Planning Commission Staff Report

Subject: Change of Zoning Issues Report

Petition: P.Z. 35-2007 and P.Z. 37-2007 Olive Greenfield Condos (14306 and 14298 Olive Blvd)

DATE 07-03-08	DESIGNED BY A.C.B.	CHECKED BY G.J.
GREENFIELD CONDOS - SITE SECTIONS		
 EDSI ENGINEERING DESIGN SOURCE, INC. 16141 SWINGLEY RIDGE RD., SUITE 300 CHESTERFIELD, MO 63017 PHONE: (636) 537-5585

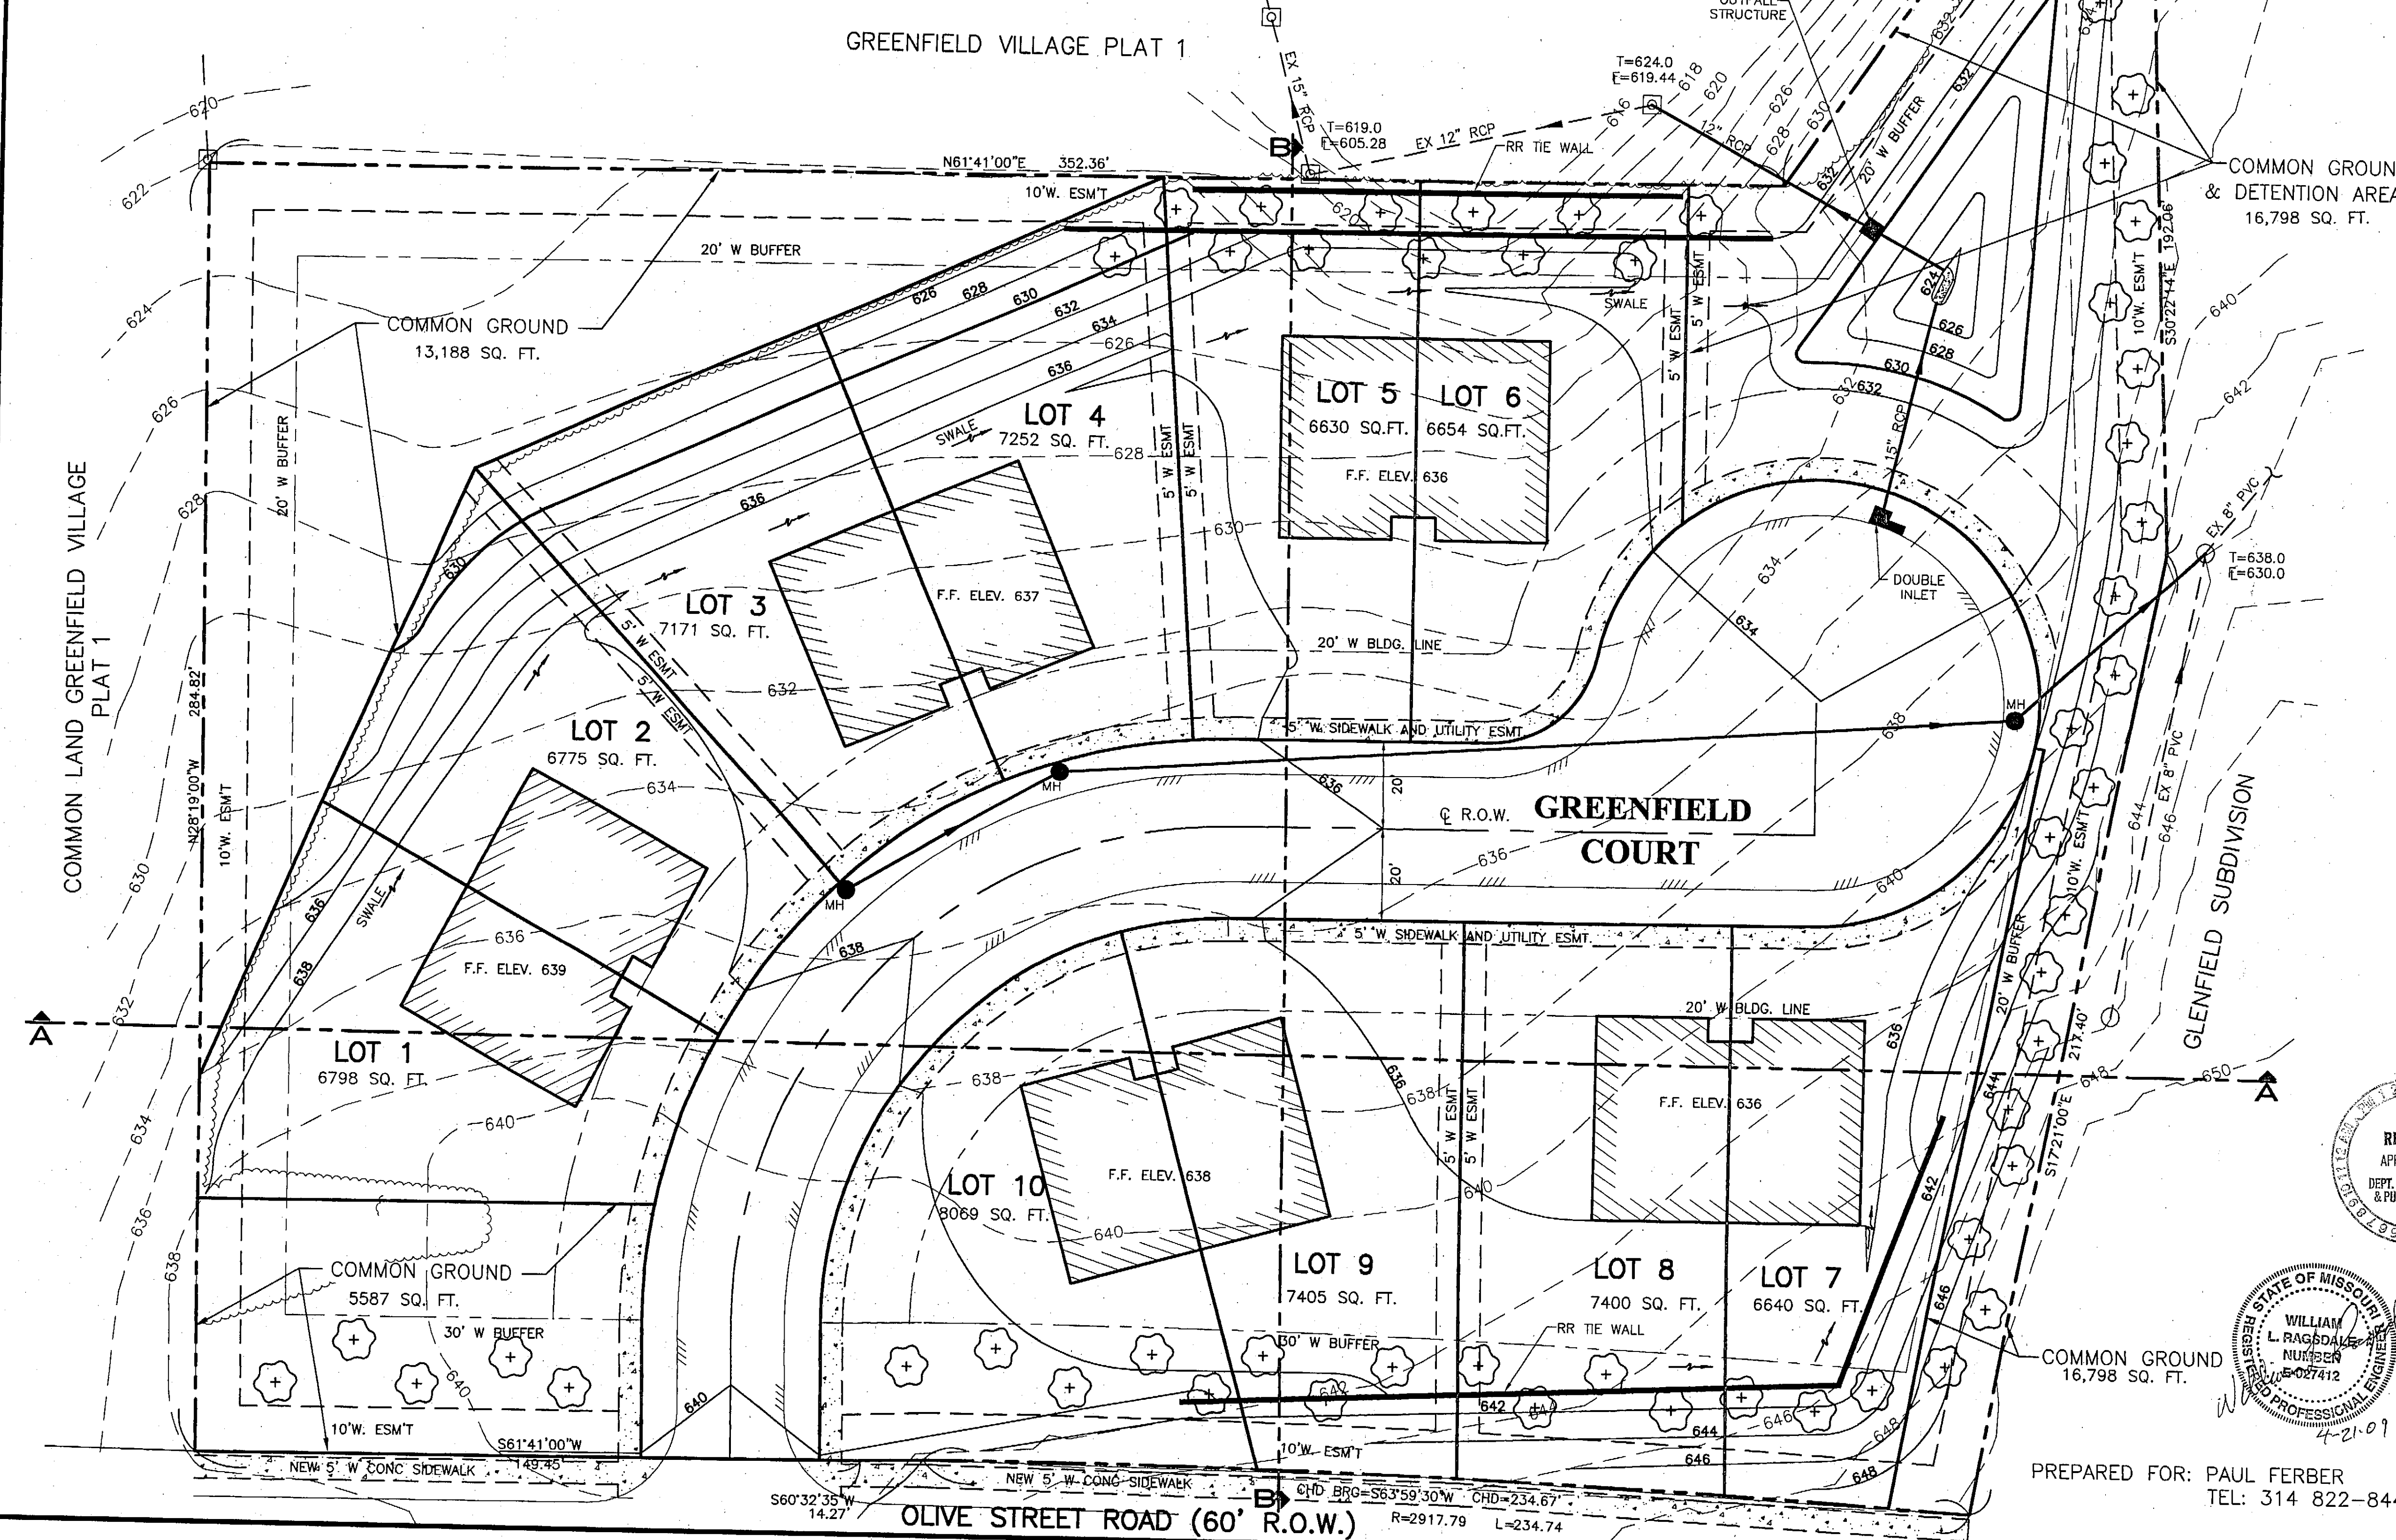
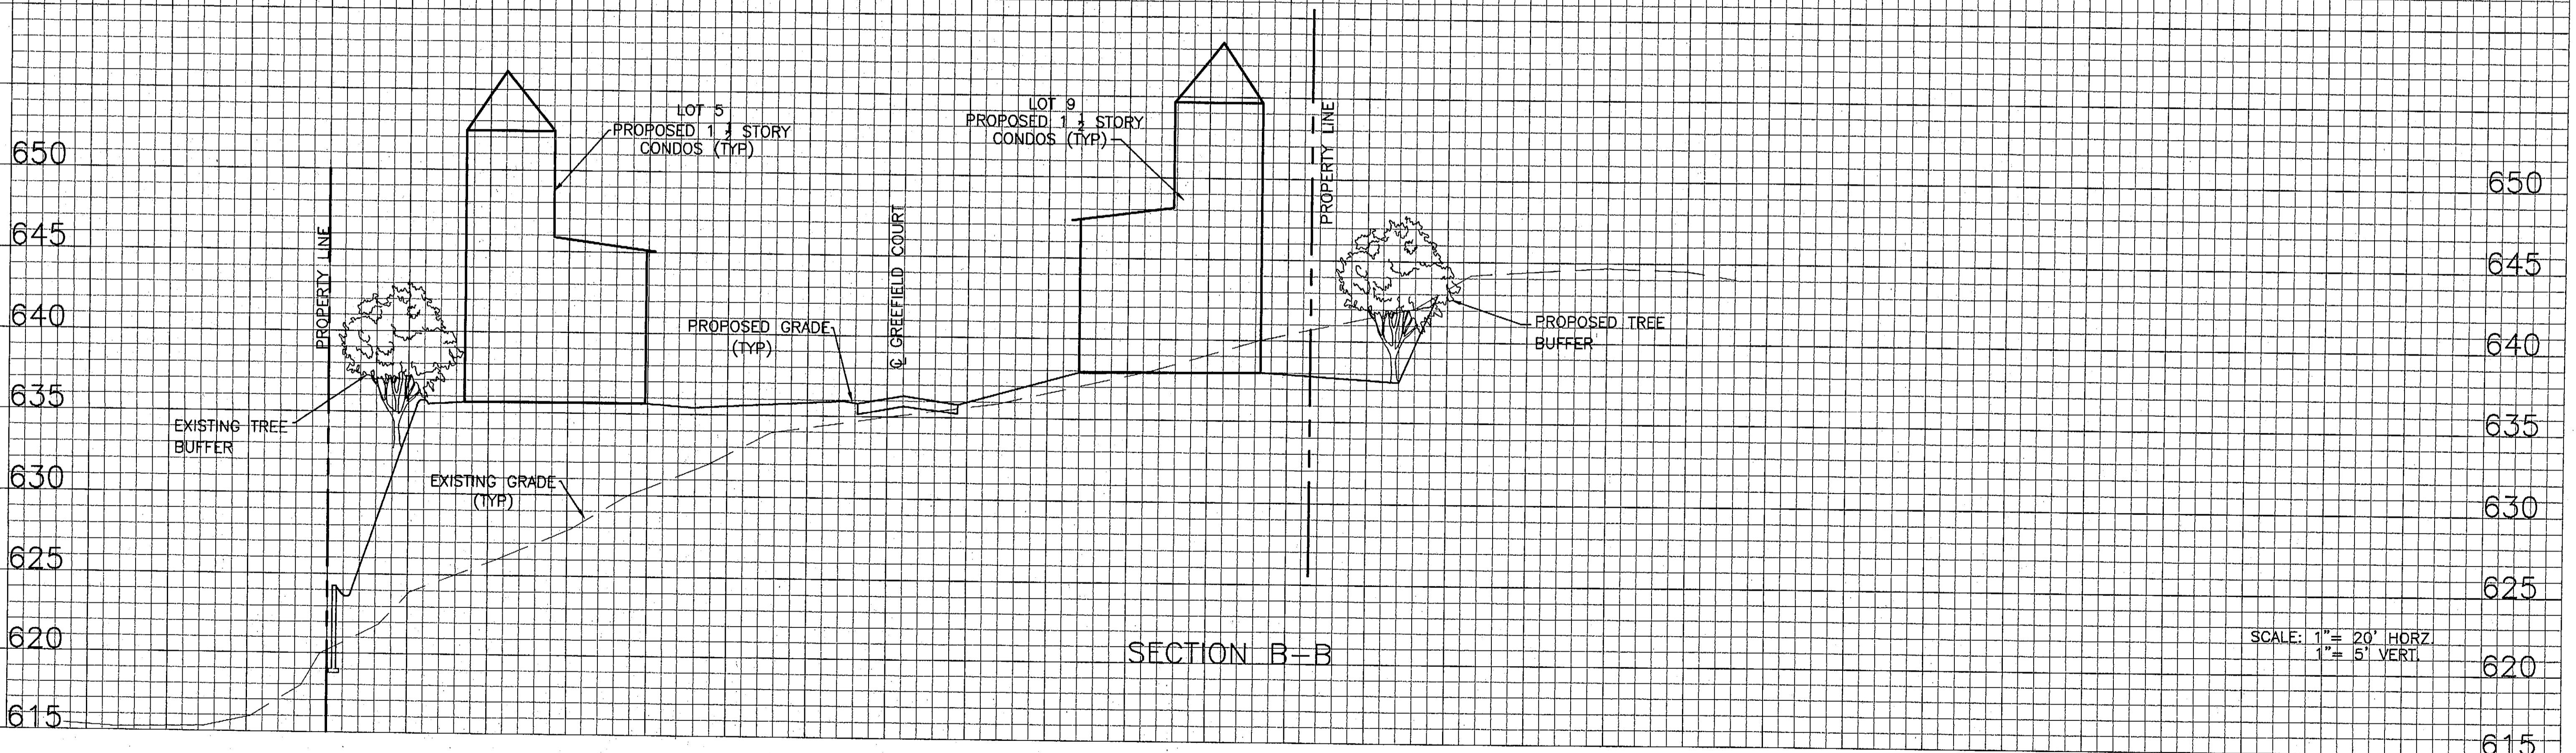
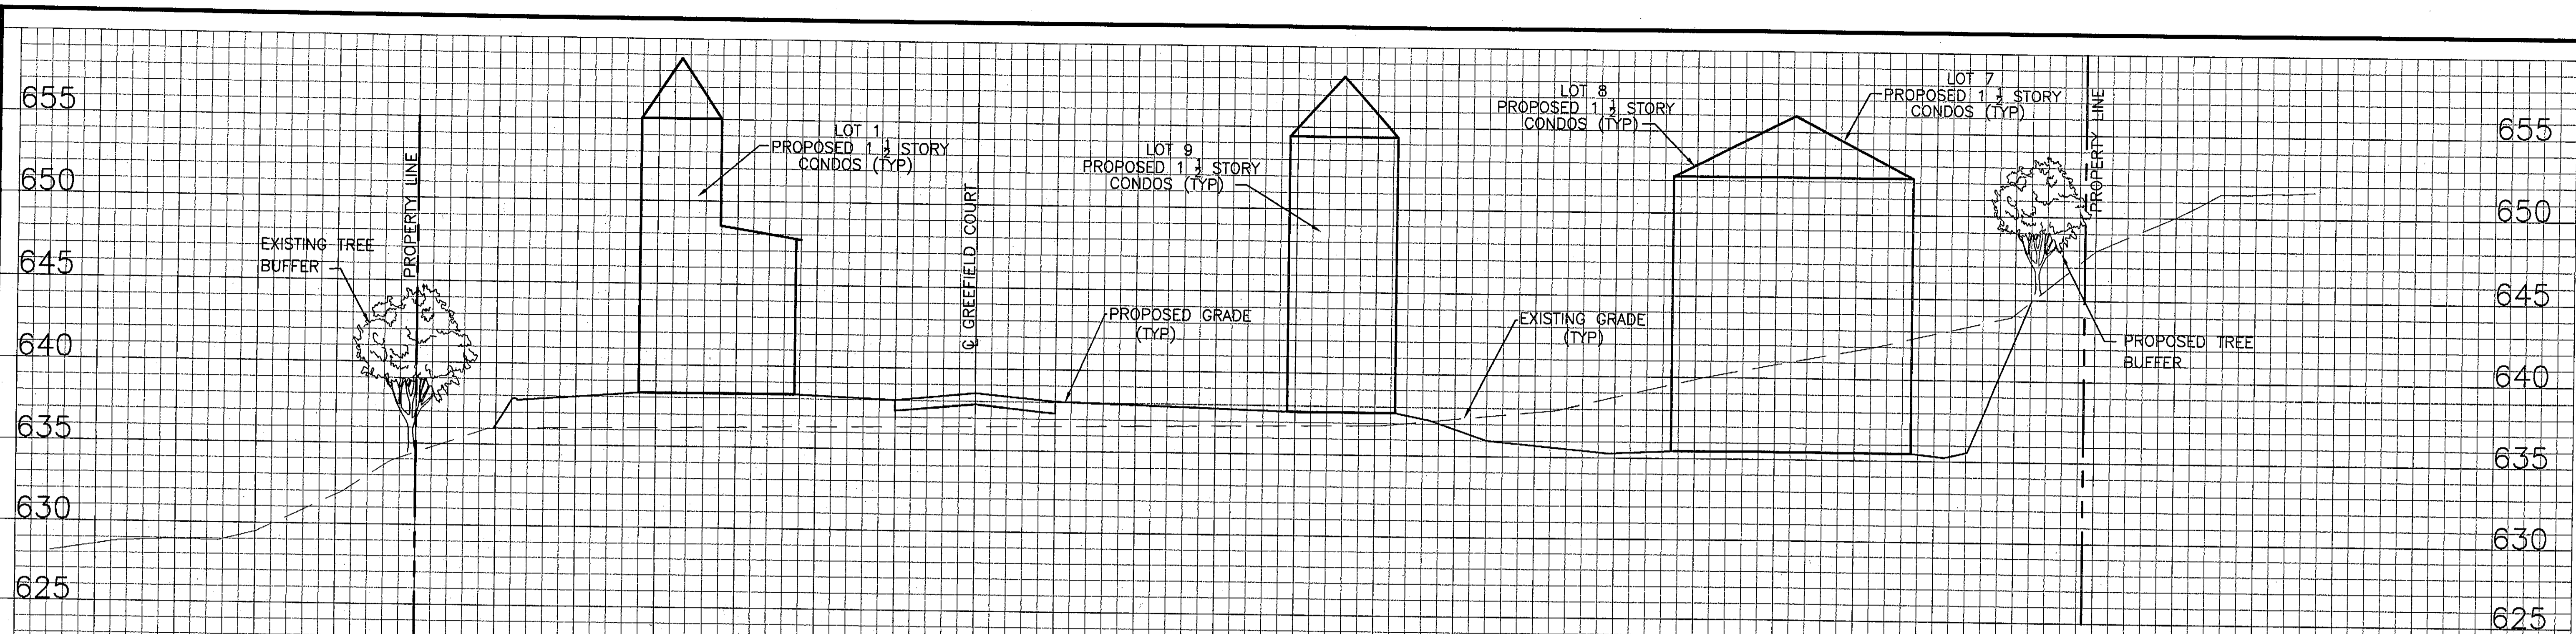
Issue eleven (11) requested a means to illustrate the elevations of the site, and proposed buildings as they relate to adjacent lots. The petitioner has submitted site section profiles as part of the Preliminary Plan that address these concerns.

11. Please provide a computer-generated model of the proposed development, which would show the heights and depths of the site.
12. Please address concerns regarding the necessity of a third party study to examine storm water runoff issues.

11. The proposed building height for a two story is as shown on the attached cross sections and their relation to the Glenfield properties. All lots from Greenfield sit substantially below the subject site.
